CITY PLANNING COMMISSION

B. Special Permit to develop three office buildings consisting of 266,136 square feet located on 20.5+ acres in the Office Building (Planned Unit Development) OB(PUD) zone.

LOCATION: Northeast corner of Gateway Oaks Drive and West El Camino Avenue

A1	CAPITOL BUSINESS PARK PHASE 1A CORNER OF W. EL CAMINO AVE. AND GATEWAY OAKS DR. SACRAMENTO, CALIFORNIA	BLDG C		MCCUEN & STEELE ARCHITECTS & ENGINEERS	COMSTOCK JOHNSON ARCHITECTS INC. <small>1172 Arden Way, Sacramento, California 95834 (916) 486-8881</small>	1 2 3 4 5 6 7 8 9 10 11 12 13 14 15 16 17 18 19 20 21 22 23 24 25 26 27 28 29 30 31 32 33 34 35 36 37 38 39 40 41 42 43 44 45 46 47 48 49 50 51 52 53 54 55 56 57 58 59 60 61 62 63 64 65 66 67 68 69 70 71 72 73 74 75 76 77 78 79 80 81 82 83 84 85 86 87 88 89 90 91 92 93 94 95 96 97 98 99 100
						101 102 103 104 105 106 107 108 109 110 111 112 113 114 115 116 117 118 119 120 121 122 123 124 125 126 127 128 129 130 131 132 133 134 135 136 137 138 139 140 141 142 143 144 145 146 147 148 149 150

EXHIBIT C

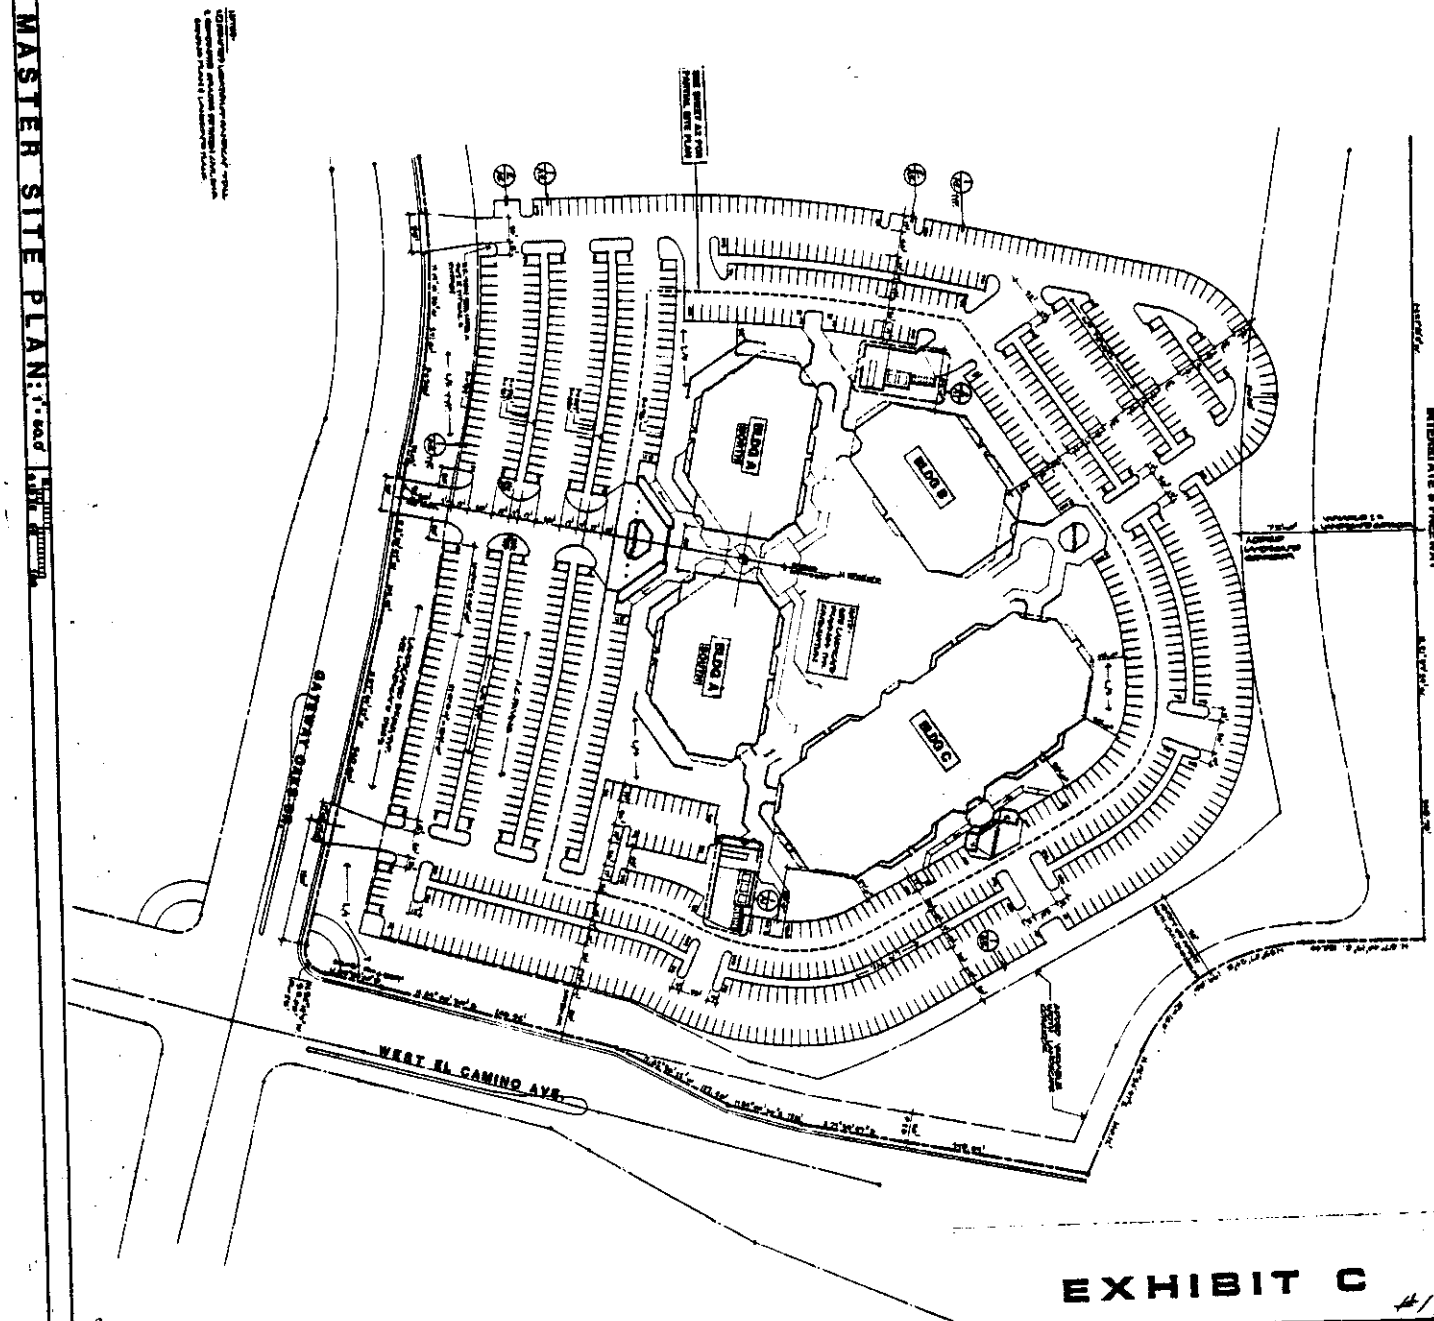
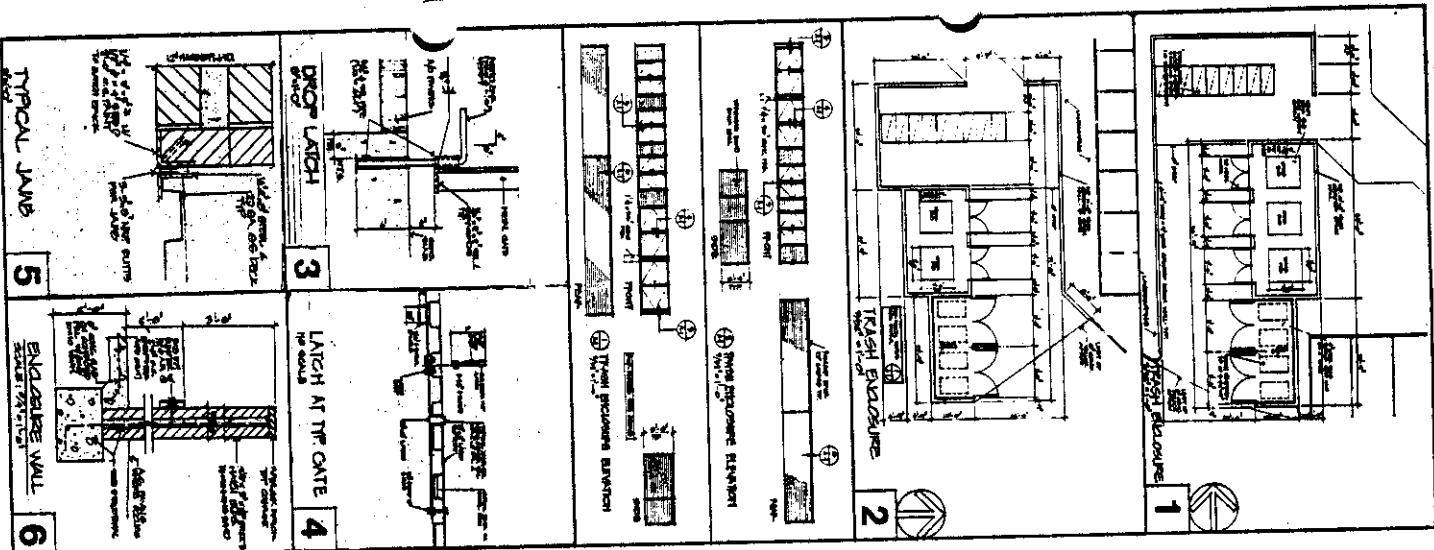
The site plan indicates long rows of parking stalls without periodic break-up with tree planters. This is particularly evident along the north property line.

The staff recommends that the site plan be revised to break-up the long rows of parking stalls with tree planters by utilizing the surplus parking spaces (the project provides 15 spaces above the minimum requirement) and by maximizing the utilization of compact car spaces (30% of the parking requirement can be compact car spaces).

1. A revised final site plan, lighting plan, detailed landscape and irrigation plans shall be submitted to the Planning Director for review and approval prior to issuance of building permit which incorporate the following changes:
 - a. provide periodic break-up of the rows of parking with tree planter strips by incorporating compact car spaces and utilizing surplus spaces;
